SUNDRY NOTICES AND REPORTS ON WELLS (DO NOT USE THIS FORM FOR PROPOSALS TO DRILL OR TO DEEPEN OR PLUG BACK TO A DIFFERENT RESERVOIR. USE "APPLICATION FOR PERMIT" (FORM C-101) FOR SUCH PROPOSALS.)		WELL API NO. 30-025-07964
1. Type of Well: Oil Well ☒ Gas Well ☐ Other ☐		5. Indicate Type of Lease STATE ☒ FEE ☐
2. Name of Operator Kratos Operating, LLC		6. State Oil & Gas Lease No. E-7194-0007
3. Address of Operator P.O. Box 769, Hobbs, NM 88241		7. Lease Name or Unit Agreement Name East 140 bbs San Andres unit
4. Well Location Unit Letter C : 330 feet from the North line and 1650 feet from the West line Section 32 Township 18S Range 39E NMPM County Lea		8. Well Number 414 9. OGRID Number 331946
11. Elevation (Show whether DR, RKB, RT, GR, etc.) 3601' GR		10. Pool name or Wildcat Hobbs San Andres East

East Hobbs San Andres Unit #914
 Lea County, New Mexico
 API # 30-025-07964

Proposed P&A Procedure:

Operator: Kratos Operating, LLC P. O. Box 769 Hobbs, NM 88241	OGRID: 331946
	Action Number: 351215
	Action Type: [C-103] NOI Plug & Abandon (C-103F)

CURRENT

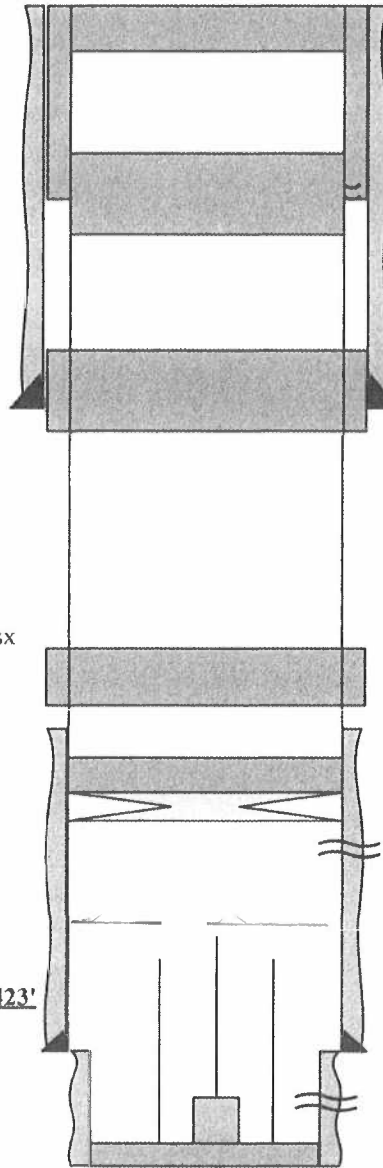
4" diameter 4' tall above ground marker

Note changes to procedure

See attached Conditions of approval
